Council Agenda Item 8.1 Attachment 4 - Applicant Response to Representations 25 Waveney Street South Launceston

Re: Response to Representations for Planning Application DA0599/2017

ThomsonAdsett completed the architectural design for the proposed Cosgrove Park Redevelopment at 25 Waveney Street, South Launceston. Since the preparation of the architectural drawings, a Development Application has been lodged and representations have been received by City of Launceston.

[Please refer to attached drawings]

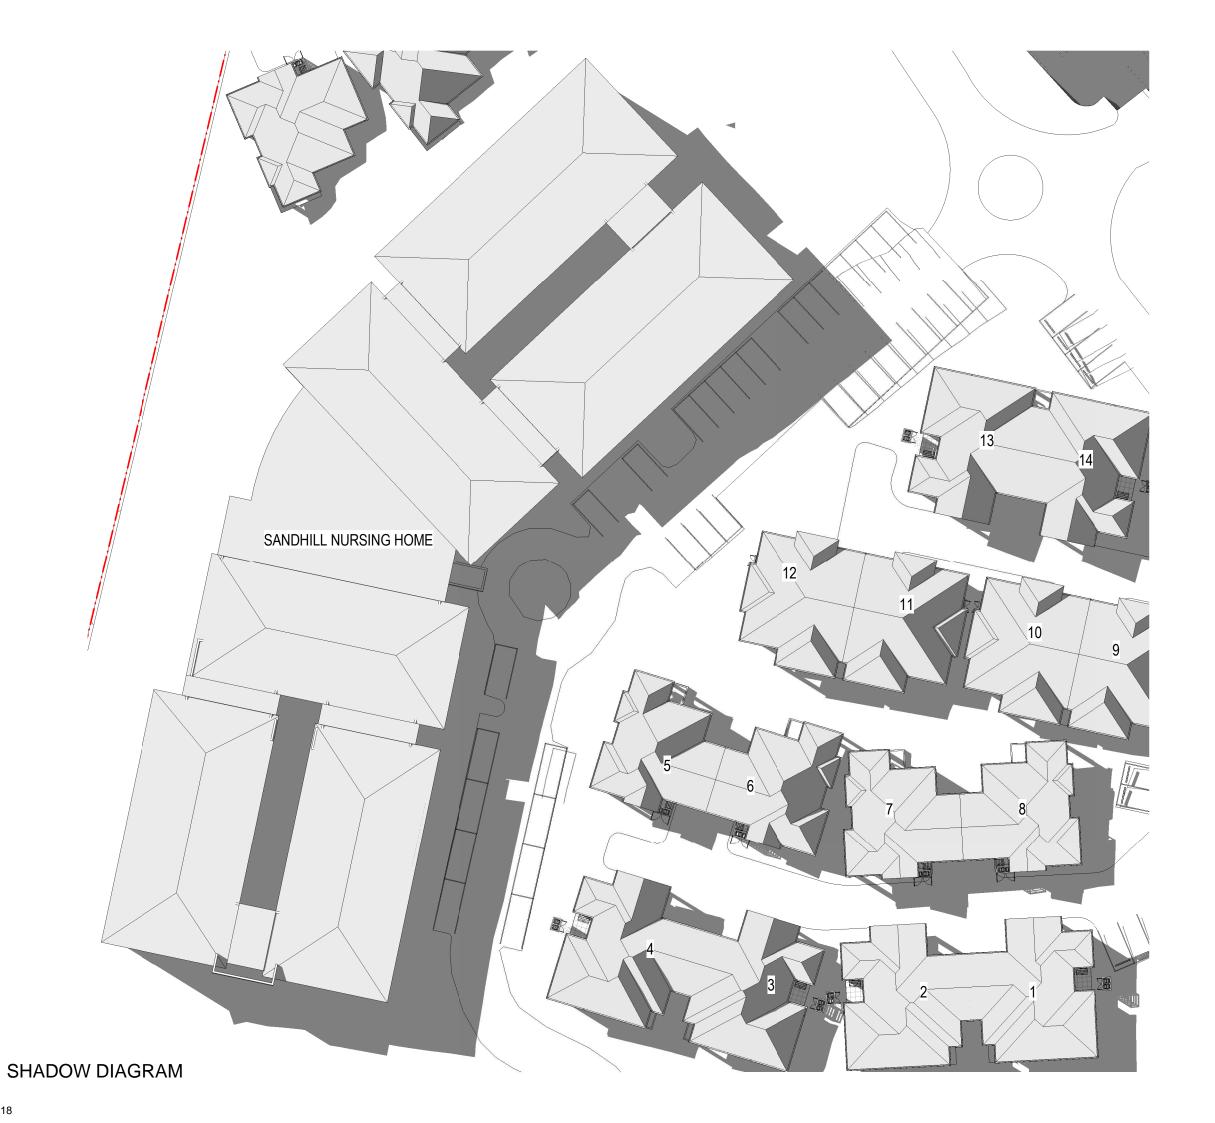
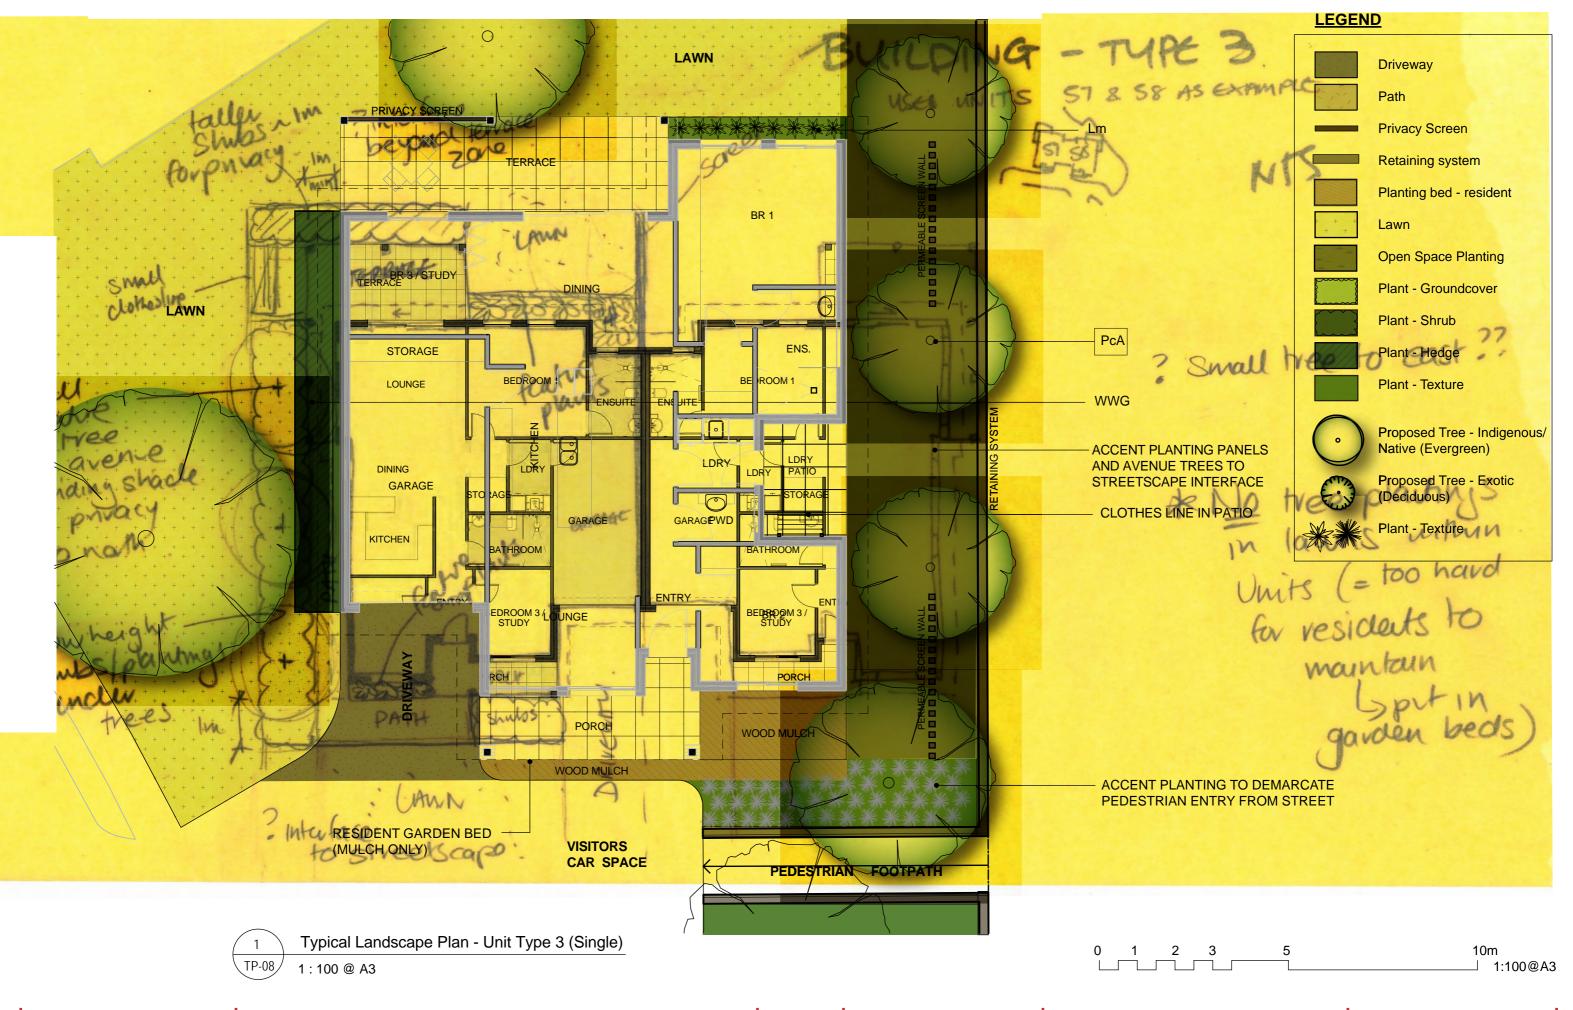
Looking at the plans units 3,4,5,6,11,12,13 are going to be on the south side of the main building and therefore in shadow. They will never get any sun, and this would have a negative impact on the residents of those units in their twilight years. It would also drastically reduce the amenity of those units.

As per sections A & B the structure referred to as the main building (Sandhill Nursing Home) is to the North West of the proposed units. The current site conditions mean that this building sits significantly lower than the proposed units. As can be seen on the sections, the proposed units will be at a higher level and significantly further south of this building. As such the shadow cast by the existing building, as can be seen on the extract shadow diagram, will fall short of said proposed new units and thus not affect the habitability of these units.
